Development Facilitation Team (DFT) – Review Comments

Project No: PR-2024-009956 **Date: 2/12/2025** **Agenda Item: #7** **Zone Atlas Page: M-9**
Legal Description: 1D, Town of Atrisco Grant, projected section 33 township 10 North range 2 East.
Request: Proposed site improvements for a new tenant building with a Taco Bell quick-service restaurant with accessory drive-thru on the end cap.
Location: 1115 Snow Vista Blvd between Sage Rd/De Vargas Rd and Benavides Rd.

Application For: SI-2024-01475 – SITE PLAN DFT

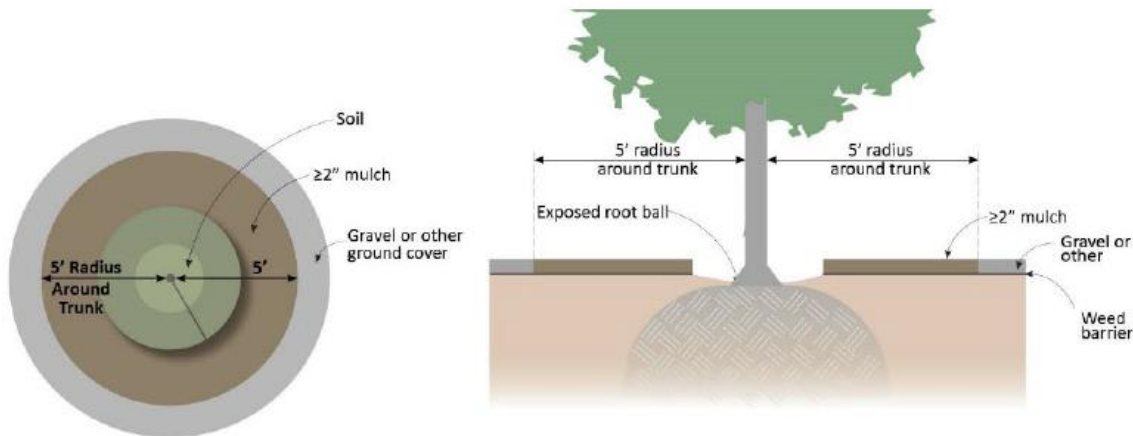
- Per 5-6(C)(5)(e) Organic mulch is required as ground cover under trees within a 5-foot radius around the tree trunk, but not directly against the trunk. In these areas, weed barrier fabric is prohibited. [The 5' radius organic mulch must be shown and called out on all tree planting details.](#) Please see the figure below from the IDO 5-6(C)(5)(e) for more clarification.

[5' Radius note previously included on standard tree detail](#)

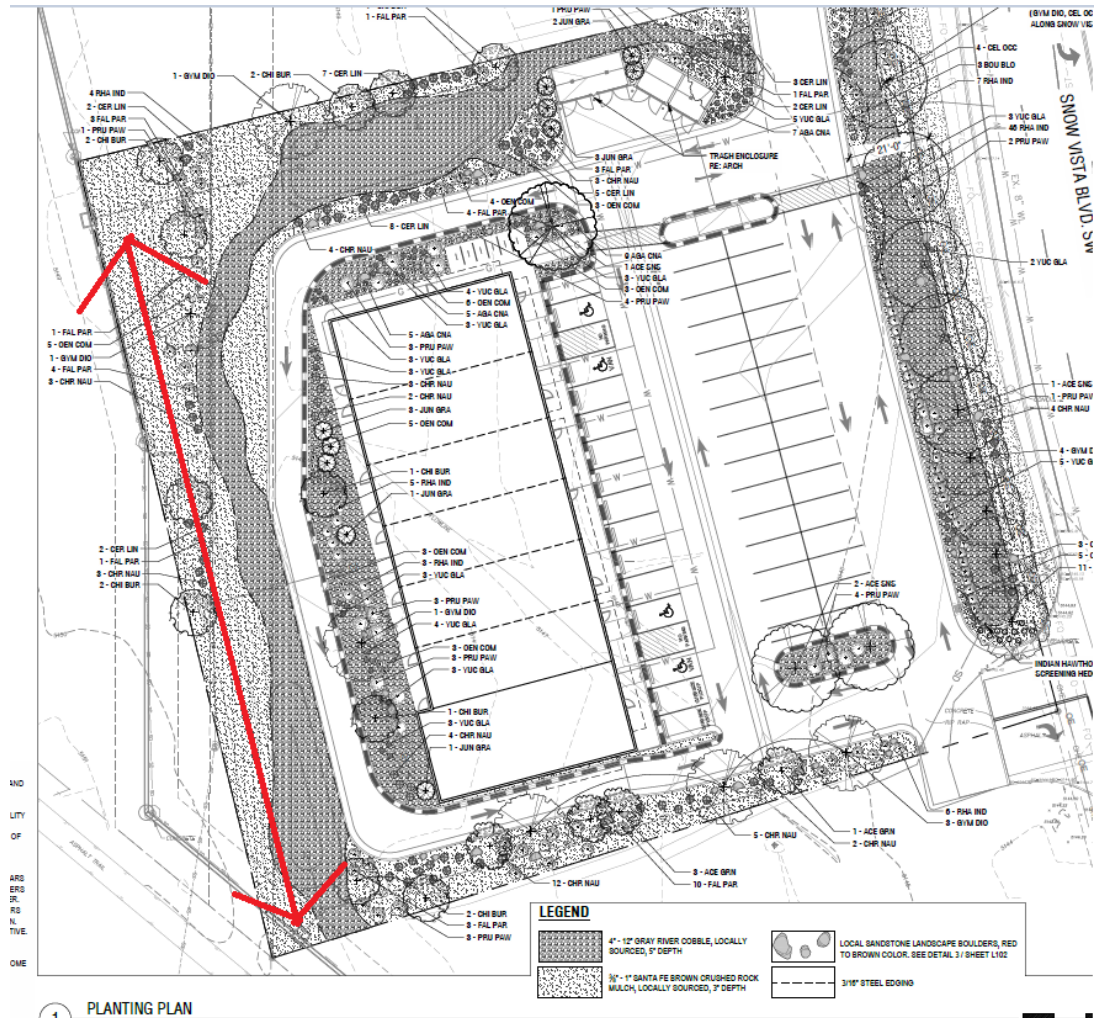
- Ponding areas must meet the requirements of Section 1013: Slope Stabilization, or better. [Please mention section 1013 in the material legend for seeding.](#)

[Section 1013 note previously included in planting notes.](#)
